Memo

From: Transport Development Control
To: Jonathan Markwell
Date: 20th March 2026
Re: Consultation on Planning Application

Planning Application Ref: PL/25/1706

Address: Forbury Retail Park, Kenavon Drive, Reading, RG1 3HS

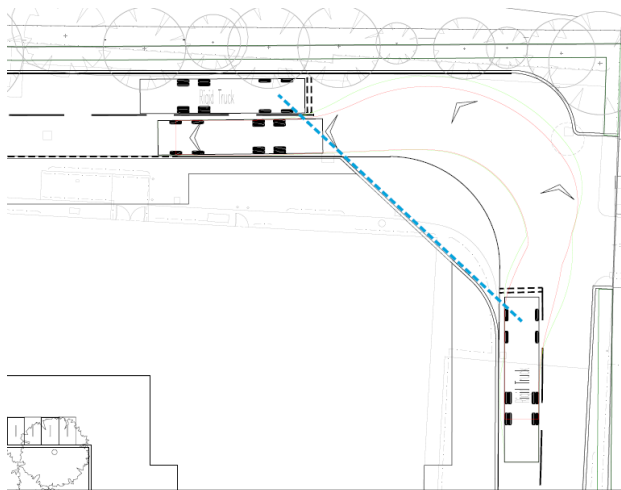
The western access point will remain a left-in and out junction, with the width of the bell mouth being reduced (in line with RBC comments to the previous scheme), and provided with improved crossing facilities. The 130 space residential basement car park is accessed through the western access point along with the 53 space at-grade commercial car park. This is shown in the outline planning application parameter plan, 'Parameter Plan 14 - Proposed Servicing & Access, ref. 18111-SQP-ZZ-GF-DR-A-PL00014'.

The eastern access point is proposed to be modified from an entry-only junction to an entry and exit access point, providing access to the service road along the Site's eastern and northern edges. The proposed access width has been increased to allow for two-way vehicle movements, as shown in Appendix F. The bellmouth width of the access junction has been widened to 8.5m and the radii of the junction increased. The ability to undertake widening of the access junction to the east is constrained by existing underground HV cables in the eastern verge that serve the sub station and are subject to a restrictive covenant. As such, the access has been widened solely to the west which will impact the TPO trees on the frontage.

Visibility splays of 2.4m x 43m in both directions should be provided as the eastern access is now to be utilised as an entrance and exit whereby it has previously been utilised as an entrance only. The Highway Authority requests that the visibility splays are submitted for review.

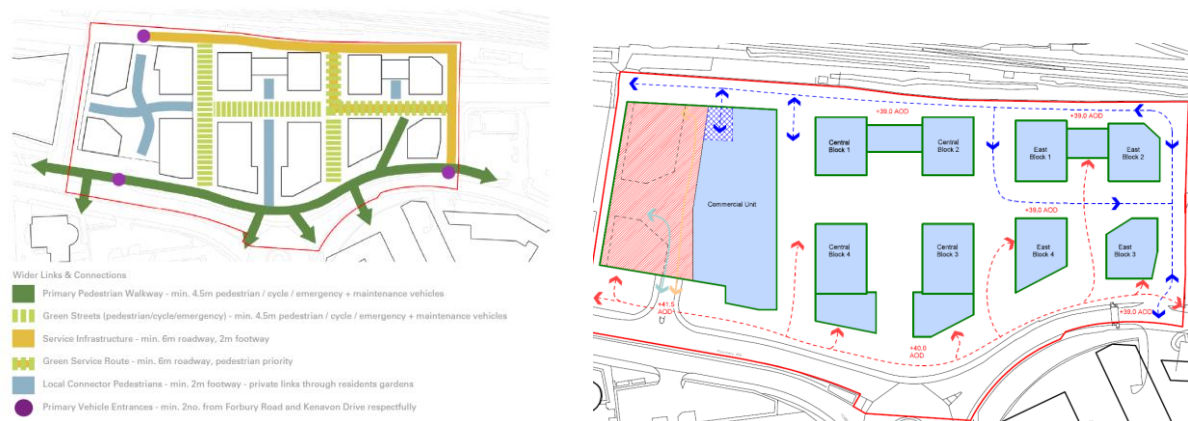
The Design Code states that a detailed waste management strategy is to be addressed within the subsequent RMA, and that refuse storage for all residential blocks should be provided at basement level. However, the Design Code does not clearly identify the servicing routes for deliveries or waste collection associated with these residential blocks.

The Transport Assessment (paras. 6.3.8-6.3.9) notes that, when required, servicing vehicles may enter the public realm to service the southern row of blocks, under management by the Estate Management Team. Nonetheless, the information provided within the Design Code, parameter plans and the supporting Waste Strategy document is insufficient to establish how servicing access will operate across the full extent of the residential development.

The Waste Strategy document states that residential collections will be undertaken from a designated collection point and returned to the bin store area after collection. However, access for refuse collection vehicles (RCV) should be considered at the outline stage as this will impact on the design of the streets and the layout of the buildings. Further clarity and confirmed routing arrangements are therefore required to ensure that servicing can be safely and acceptably accommodated without compromising the functionality of the public realm. The pedestrian and cycling links must not be compromised by adjacent functions such as servicing, and appropriate serving/delivery bays must be identified within the Design Codes document.
